Staff Report

Re: Application for 46 Renfrew Avenue for the following:

The Town has received an application for construction of Lakewood Manor, a 30-unit senior's living apartment building at 46 Renfrew Avenue.

Review of Development Permit Application, DP002-2024

Figure 2 Materials Key

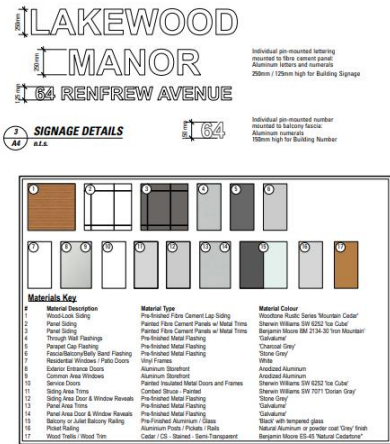
- a) Comment
 - i) A variety of building materials will be employed (See figure in Recommendations):
 - (1) Wood-Look siding, Rustic Series Mountain Cedar

- (2) Panel siding, painted fibre cement panels with metal trim, Sherwin Williams Ice Cube and Benjamin Moore Iron Mountain
- 4) Use natural materials such as timber, stone, and brick for exterior finish highlights.

- a) Comment
 - i) Wood look siding dominates much of the building.
 - ii) We have requested actual timber for entry highlights, however, the architect has advised, subject to the Cowichan Elder Care Society's approval, to use stone features instead on the first floor.

Figure 4 Site Plan and Landscaping

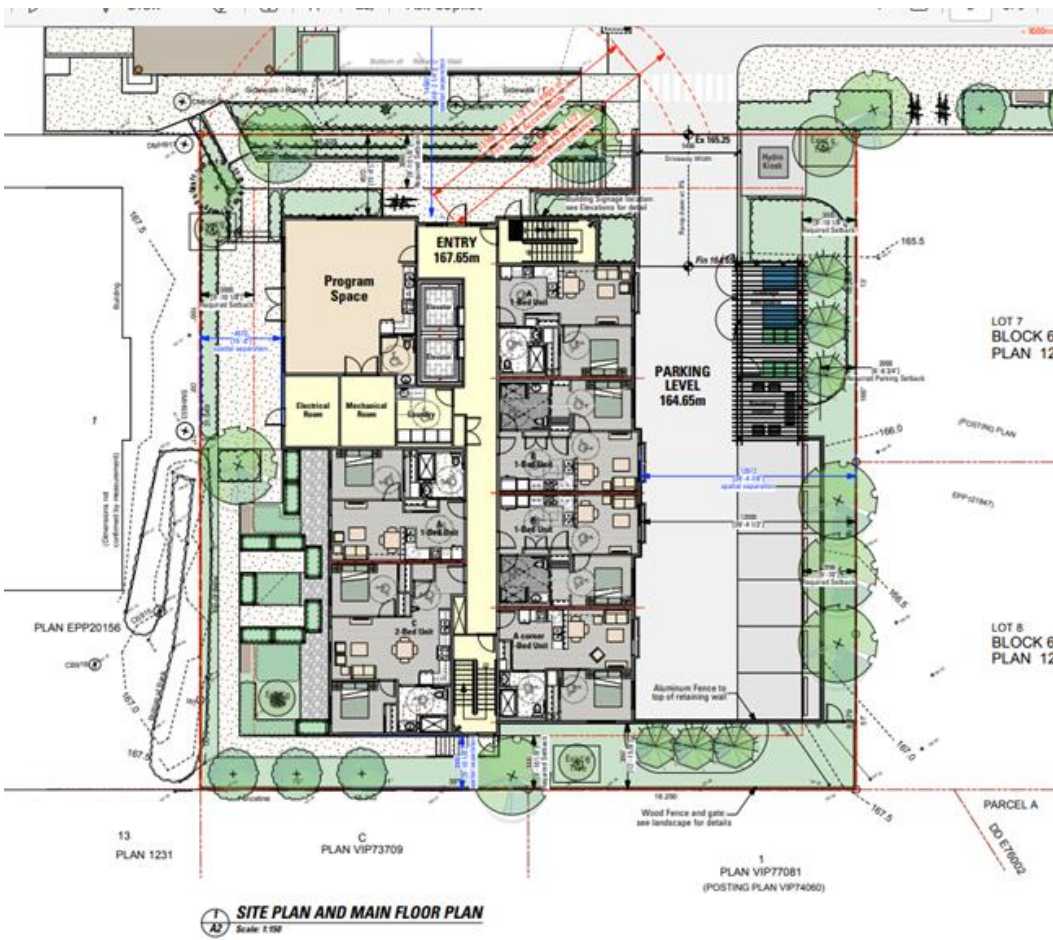
A review of the submitted landscaping plan resulted in several modifications to the plan, specifically reduced shrub planting in FireSmart Zone 1a (0-1.5 metres) and elimination of all mulch within FireSmart Zone 1 (0-10 metres).

- a) Comment
 - i) Extensive landscaping and appropriate fencing are provided. (see figure in Recommendations)
- 7) Design in keeping with the west coast climate with particular attention to rain related design that includes overhangs and covered walkways. The design of buildings should also acknowledge the varying influence of sunlight during the day and on a seasonal basis and should take advantage of natural light.

- a. Approval of the development as presented, with conditions, inclusive of the following specific site plan, landscaping plan, site fencing, and use of building materials as shown in the profiles herein and on file in the Town Office:
 - i. Prior to the building permit \$88,000 shall be provided as landscaping surety for a period of 2 (two) years.
